Accessibility Survey

City of Glendale

Downtown Parking Lot #11

Inspected January 2008

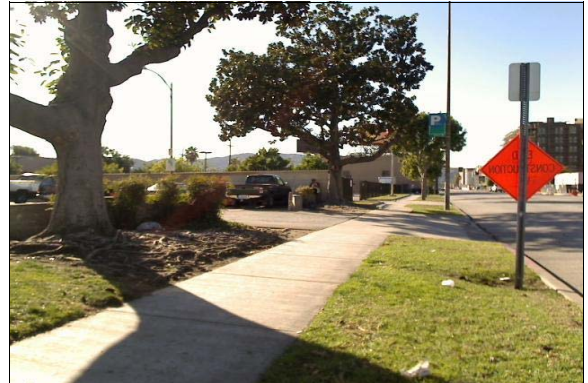
Finding: There are no accessible parking spaces out of 66 parking spaces which does not meet the minimum number for compliance.

Full Rec: Three (3) out of 66 total parking spaces are required to be designated exclusively for accessible parking. Create three accessible spaces, each measuring at least 108 inches wide and 216 inches long. Designate one parking space as "van-accessible". The van-accessible space shall provide an access aisle measuring at least 96 inches wide on the passenger side the space. The two additional parking spaces shall each provide an access aisle measuring at least 60 inches wide, that may be shared. Add the words NO PARKING in 12 inch high white letters at the entrance to each accessible parking access aisle.
